From: [REDACTED]
To: ["developmentcontrol@luton.gov.uk"](mailto:developmentcontrol@luton.gov.uk)
Cc: [REDACTED]
Subject: Planning applications 16/01400/OUTEIA and 16/01401/OUTEIA
Date: 27 March 2017 11:45:20
Attachments: [image001.jpg](#)
[Power Court Luton. \(2\)..docx](#)
[Land Adjacent M1 Junction March 2017\).docx](#)

Project:	Highways England Spatial Planning Arrangement 2016-2020	Job No: 60506522 DL005.006
Subject:	Newlands Park – TA Second Addendum Review	
Prepared by:	[REDACTED]	Date: 13/04/2017
Checked by:	[REDACTED]	Date: 19/04/2017
Verified by:	[REDACTED]	Date: 21/04/2017
Approved by:	[REDACTED]	Date: 21/04/2017

Doc Ref: 32444 LTFC Planning Applications – ‘Transport Assessment – Addendum Report 03

Figure 1 – Potential queue vs queue length available

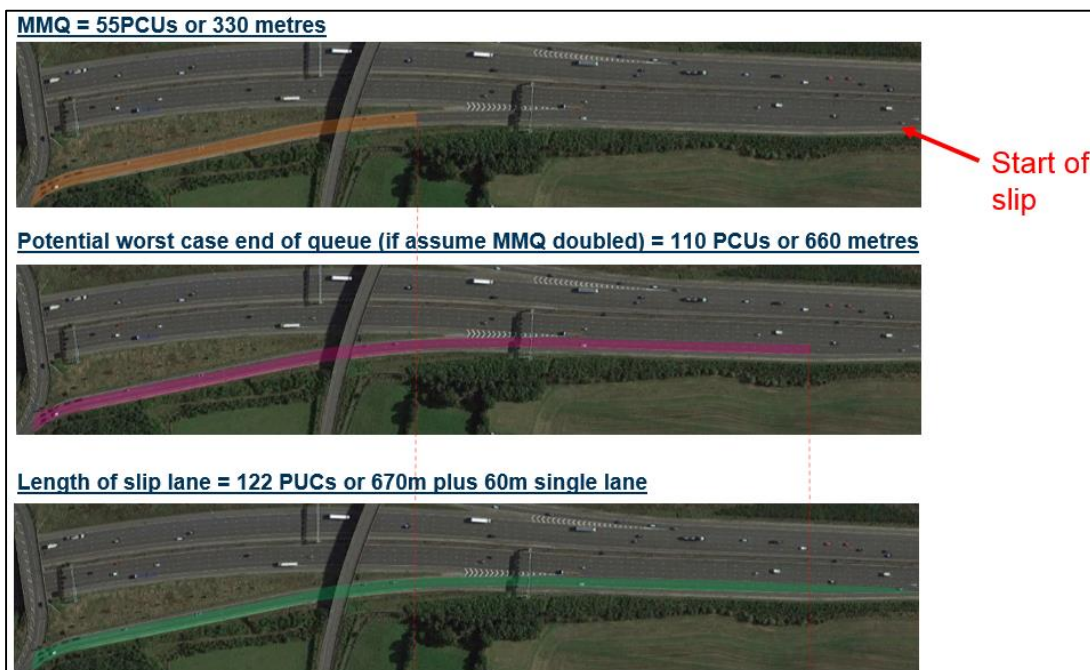
PBA Response

In this case, as the DoS is not higher than 110%, and therefore oversaturated queueing is not expected to occur every cycle and instead residual queueing at the end of each cycle is much more random (i.e. sometimes it occurs and sometimes not). Therefore, the theoretical methodology of doubling MMQ to obtain the end of period queue would provide an overestimate of the maximum queue. Also, as the slip lanes have queue detector loops (located 50m and 140m from the stop line), it is possible (on the ground) to significantly reduce the risk of residual queueing at the end of each peak period cycle by extending and therefore providing sufficient green time to clear the queue.

Nevertheless, even if this scenario is to occur the queue will only ever reach this maximum length (110 PCUS) at the end of the peak hour and will only occur for a very short period of time. It should also be noted that the two slip lanes are currently each 670m (plus 60m of single slip lane) long and therefore provide sufficient queueing capacity to accommodate 233 PCUs @ 6m PCU lengths (i.e. 1,400m of total queueing length). At the end of the peak hour the total queue ‘could’ (according to the user guide) therefore reach 220 PCUS (1,320m queueing length), which would still be contained fully within the slip lane and not extend back onto the mainline (i.e. 80m or 13 PCU spare queueing capacity). These queueing lengths are shown in Figure 1.

It is also worth noting that for 50% of the peak hour the total queue will be less than the Mean Max Queue quoted of 55 PCUs.
